MFN 06-274  
Supplement 1

**Subject: Response to Portion of RAI Letter Number 20 Related to ESBWR Design Certification Application – Seismic Design – RAI Numbers 3.7-16S1, 3.7-24S1, 3.7-30S1, 3.7-33S1, 3.7-35S1, 3.7-38S1, 3.7-39S1, 3.7-50S1, 3.7-54S1 and 3.7-57S1 – Supplement 1**

**ENCLOSURE 1**

**Response to Portion of RAI Letter Number 20**

Figure 7 Mode Shape No. 3

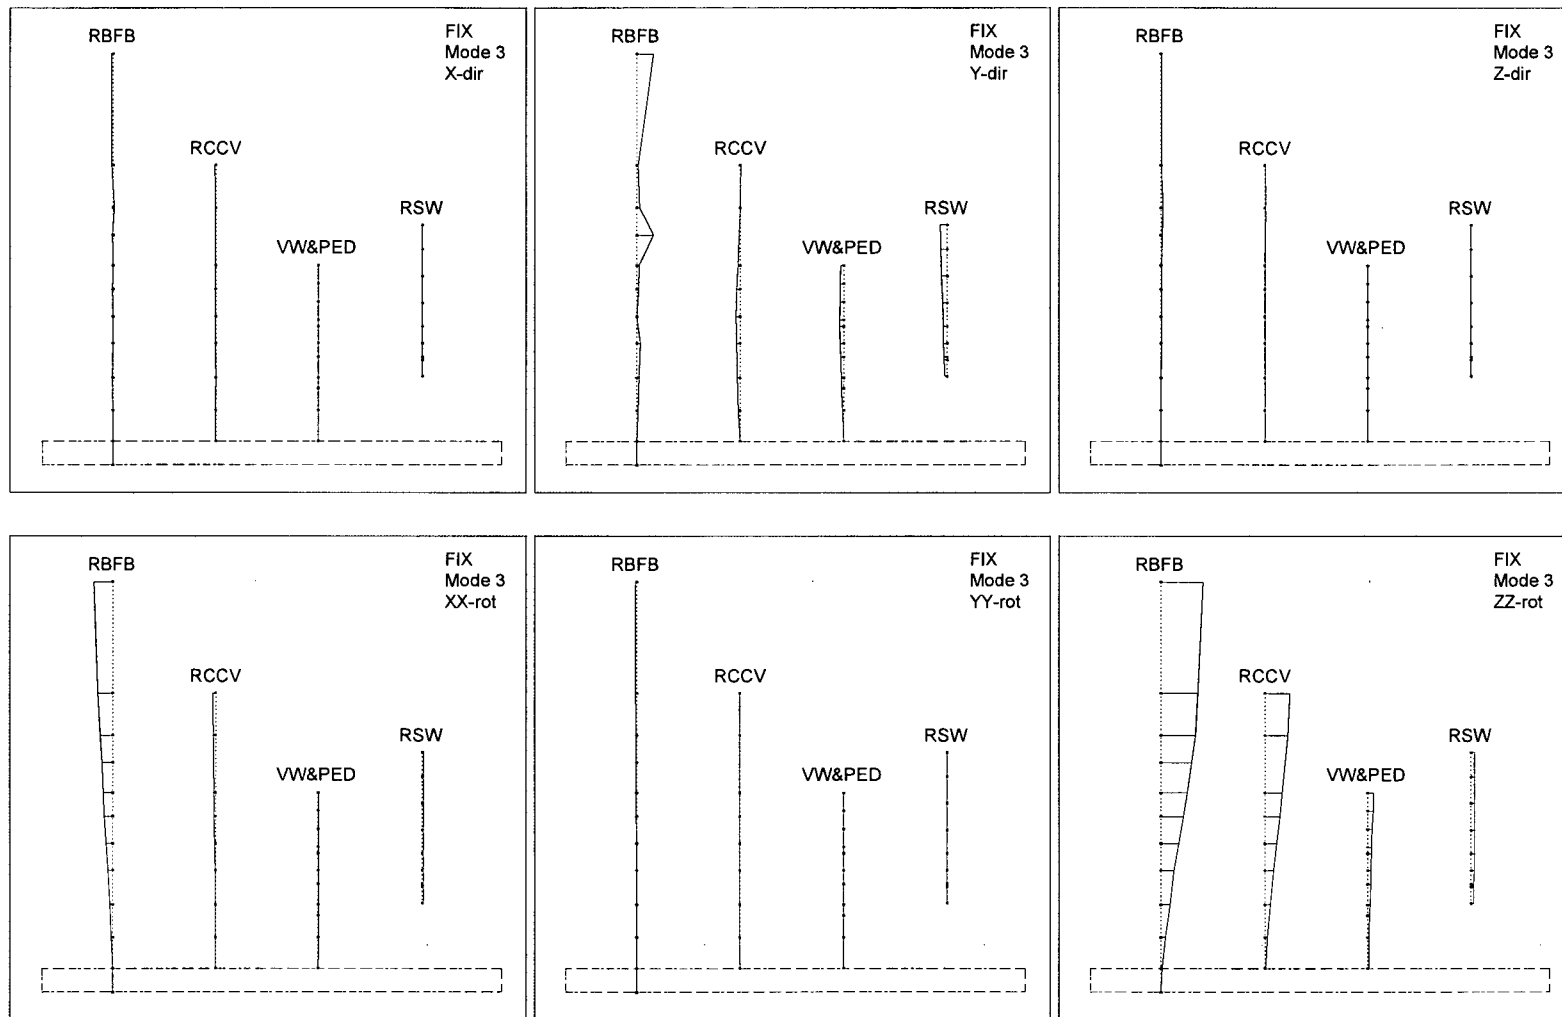
In the NRC audit, the mode shape of mode No. 3, which contains torsional mode, was discussed. The issue was why the Y direction translation of the RBFB node 107 at EL 22.5m is larger than the other adjacent floor nodes.

The RBFB seismic stick model is a 3-D model considering the building eccentricity as shown in Figures 1 through 4 in Attachment SER-ESB-054. The RBFB node 107 at EL 22.5m is located south of the other adjacent floor nodes, because of the FB roof weight. Therefore, if a torsional mode is predominant in mode No. 3, Y direction translation of this floor becomes larger than those of the other floors.
